TB 79B

TECHNICAL BULLETIN

Product : System 21 Passenger Lifts

Subject : Optical proximity switches (OPS), operational testing.

Diagram 1

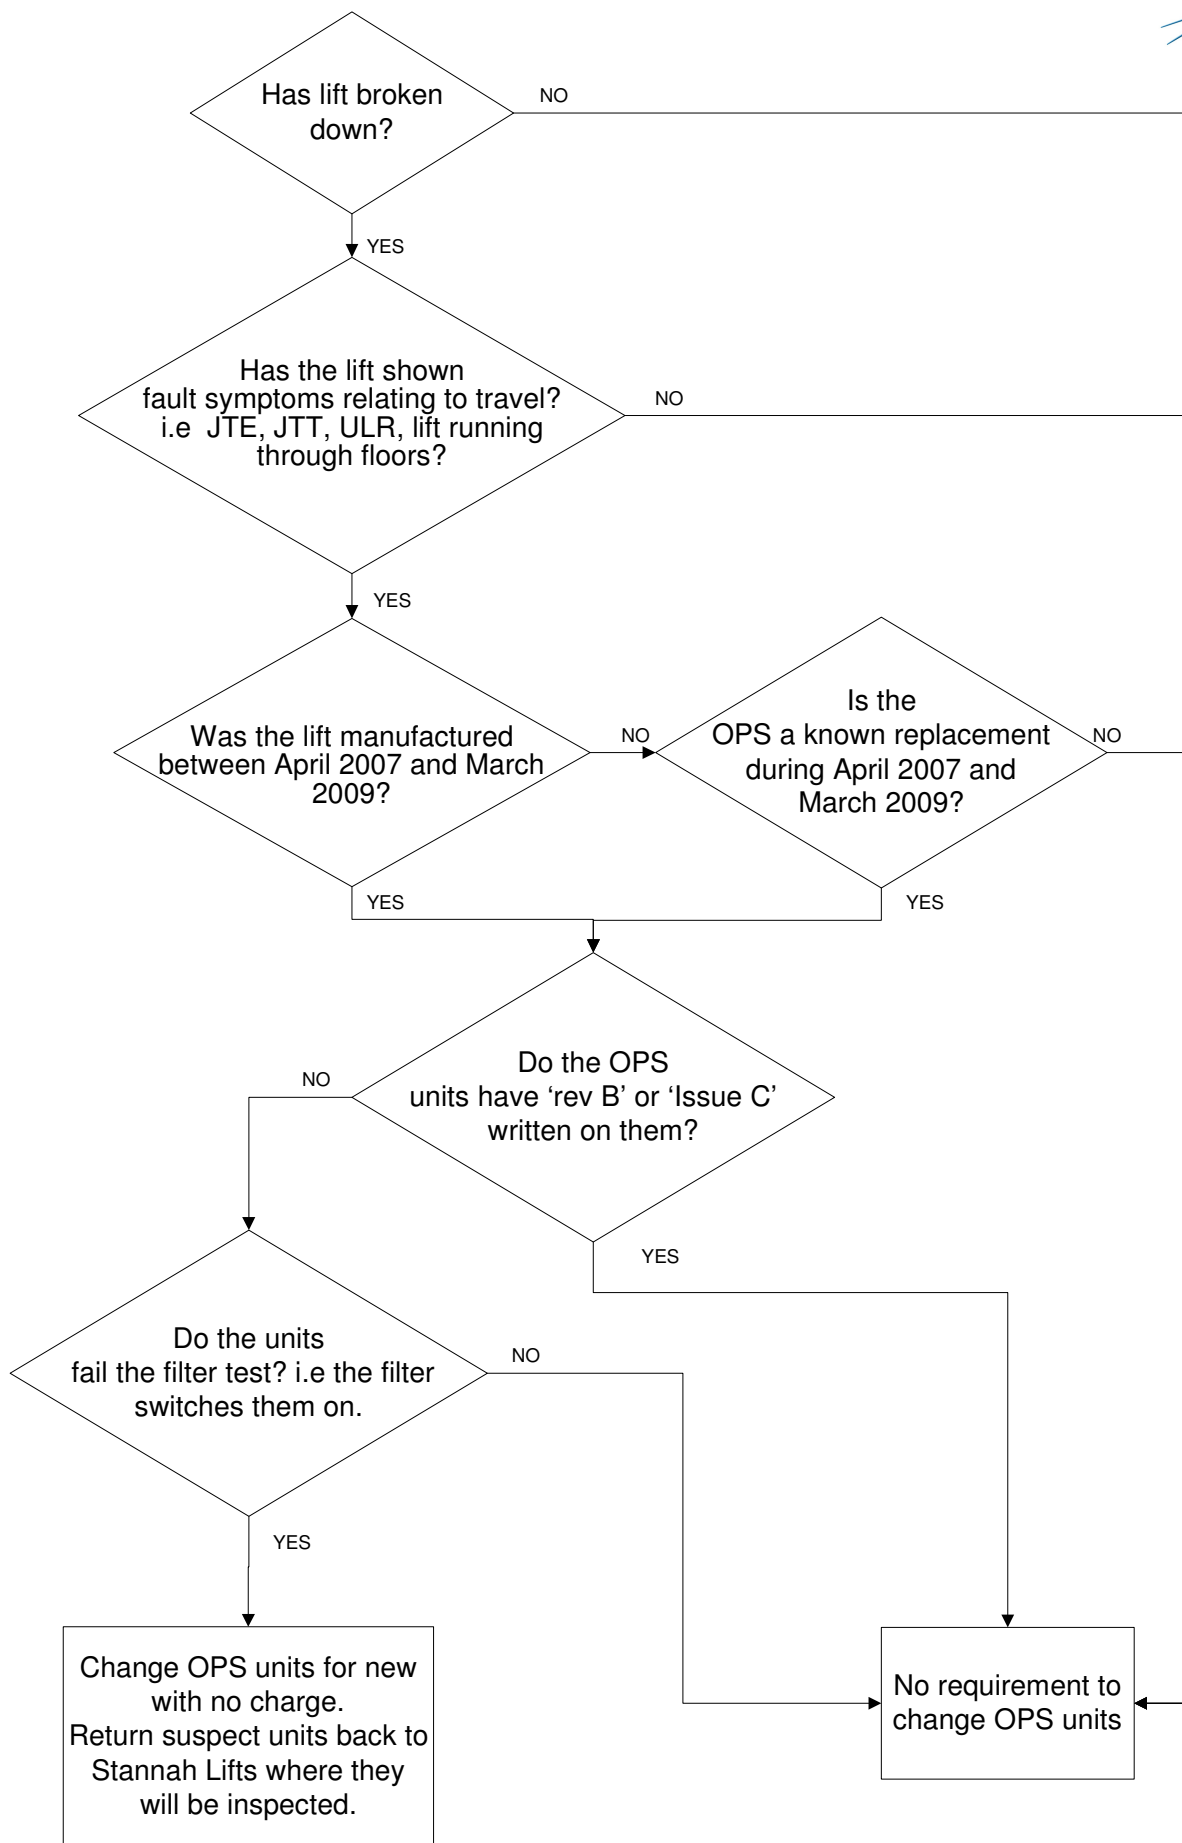
- This information only affects passenger lifts manufactured after April 2007 up until March 2009.
- If the OPS has 'REV B' or 'Issue C' written on its label then it is from a 'good' batch and should not need replacing. This bulletin can be ignored. See diagram 1 at the end of this document for clarification of identification.
- This also includes OPS units purchased as spares during the same period.

BOTH UNITS ARE FROM GOOD STOCK AND HAVE CORRECT SPECIFICATION LED FITTED.
